RE: Recommendation to Approve a 112d-2 Permit Amendment Application (AM-6) with Objections; Colorado Legacy Land, LLC; Schwartzwalder Mine; Permit No. M-1977-300

Schwartzwalder Mine, Permit No. M-1977-300

RE: Rationale for Recommendation to Approve a 112d-2 Permit Amendment Application (AM-6) with Objections; Colorado Legacy Land, LLC; Schwartzwalder Mine; Permit No. M-1977-300

FIGURE E-4 GROUNDWATER MONITORING LOCATIONS

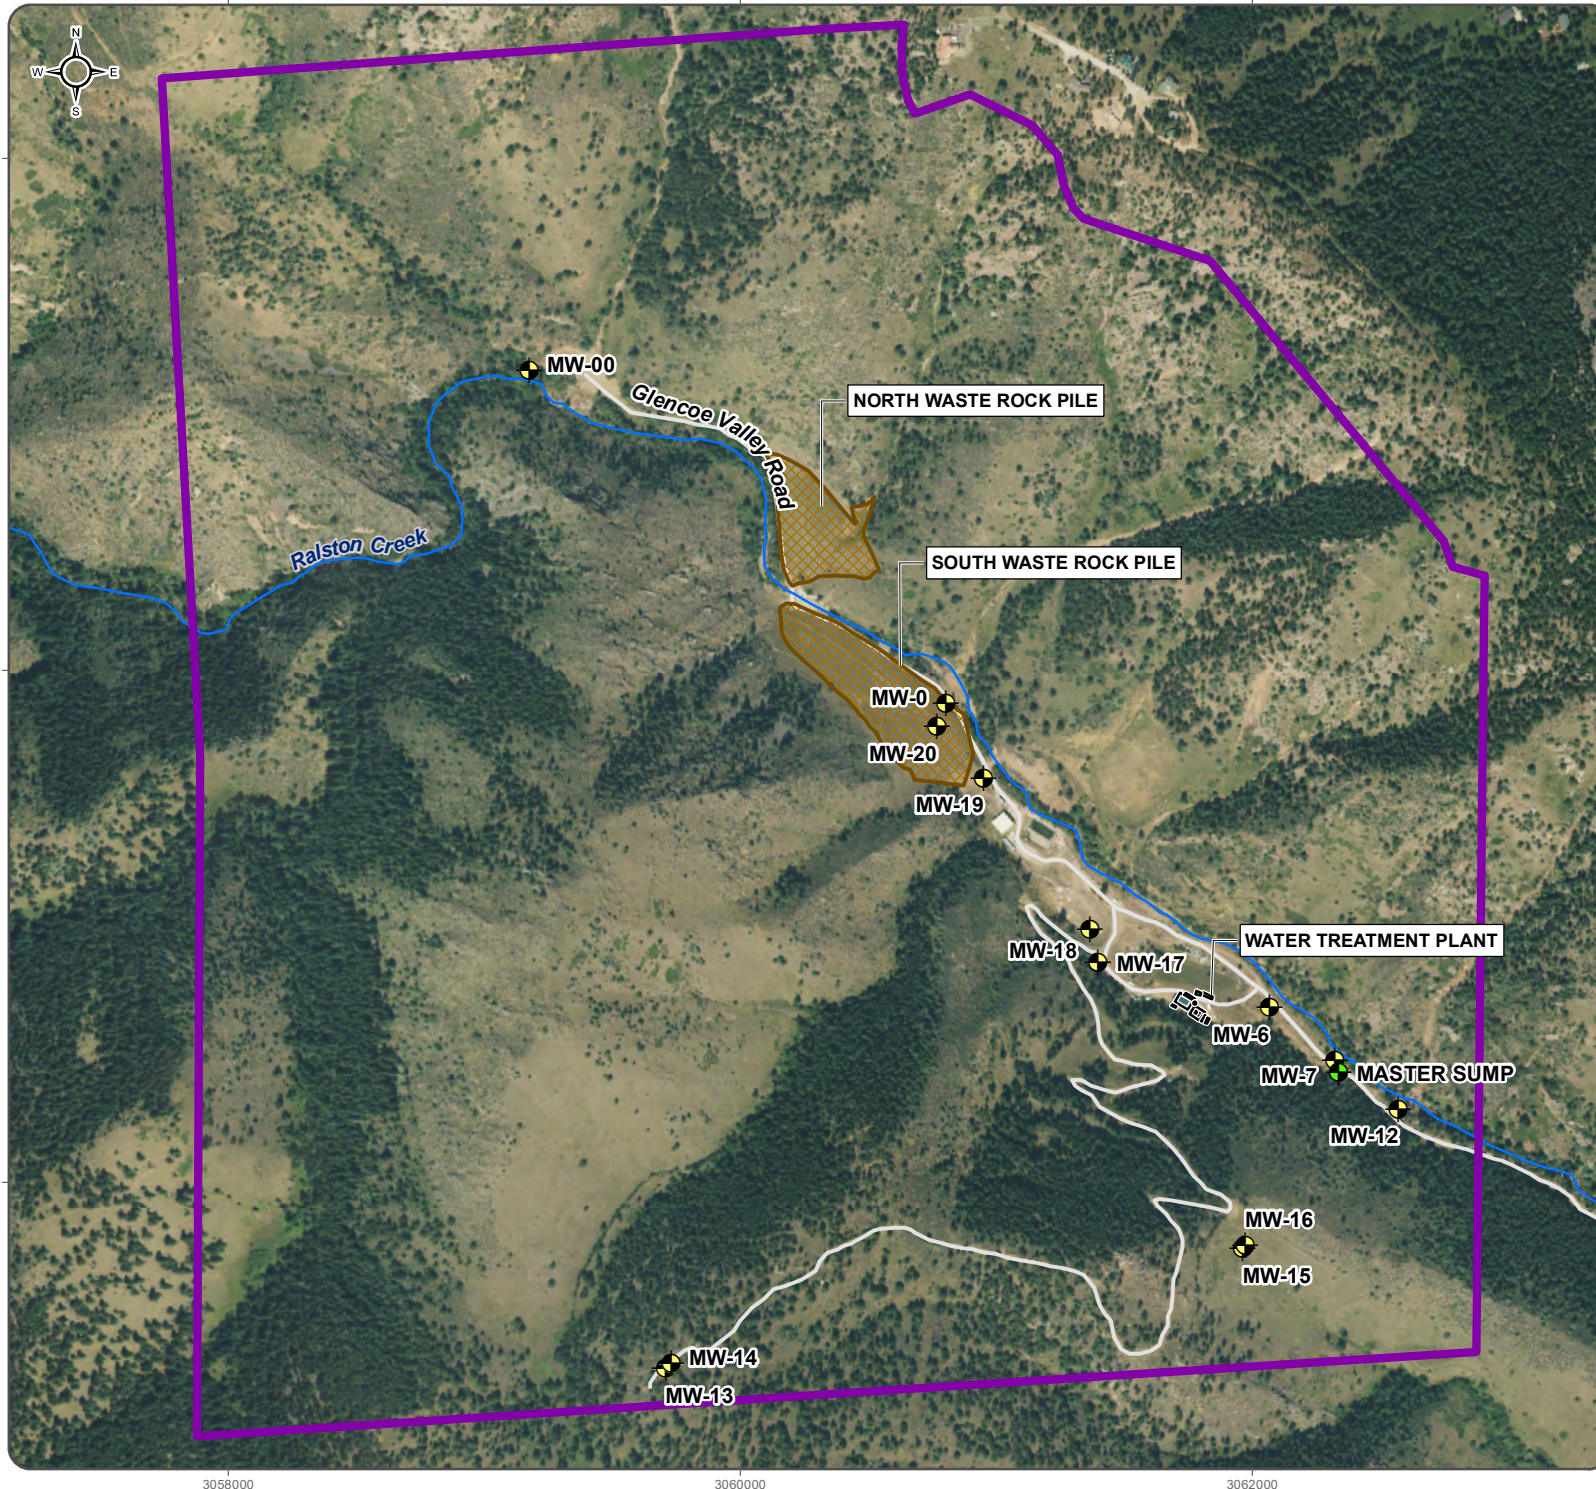
- *With only two monitoring wells used to estimate groundwater gradients, there is insufficient evidence that the mine pool is contained. Data on only two wells (MW-15 and MW-18) were provided in the amendment in Table E-1. (City of Arvada)*

- *CLL does not provide sufficient data to assert that physical stabilization of the mine pool has occurred. CLL uses only two bedrock monitoring wells, one of which only has three data points dating back to Q2 2020. This does not demonstrate physical stabilization of the mine pool for the last three consecutive years, as required by the SO-1 approval letter. CLL should continue collecting bedrock groundwater data and consider installation of additional bedrock wells to further refine the CSM. (Denver Water)*

Data obtained over the past four consecutive years from bedrock monitoring wells MW-13, MW-15, and MW-18 (see Attachment C), and also from the transducer installed in the mine pool (which acts as a pumped well), indicate that maintaining the mine pool elevation below the regulatory limit of 150 feet below the Steve Level has established a hydraulic gradient inward toward the mine pool and away from Ralston Creek, as was intended when the regulatory limit was established by the Board in 2012. Monitoring well MW-13 (total depth = 500.8 feet bgs) was installed as a deep upgradient monitoring well; MW-15 (total depth = 1,007.13 feet bgs) was installed east of the mine targeting the Schwartz Trend geologic transition zone, and downgradient of the mine relative to pre-mining static water levels; MW-18 (total depth = 239.9 feet bgs) was installed in the valley floor targeting the Illinois Fault in the area where this fault is adjacent to the creek. The two geologic features (Schwartz Trend and Illinois Fault) targeted by monitoring wells MW-15 and MW-18 were thought to be potential migratory pathways for the mine pool at the time when the mine workings were flooded. These three deep groundwater monitoring wells were installed in 2012, prior to the mine pool being dewatered below the regulatory limit in late 2017. Once the mine pool was brought below the regulatory limit, the gradient from the bedrock wells ranged from 0.014 to 0.304 feet per foot. This data indicates the hydraulic gradient in the mine area is toward the mine workings.
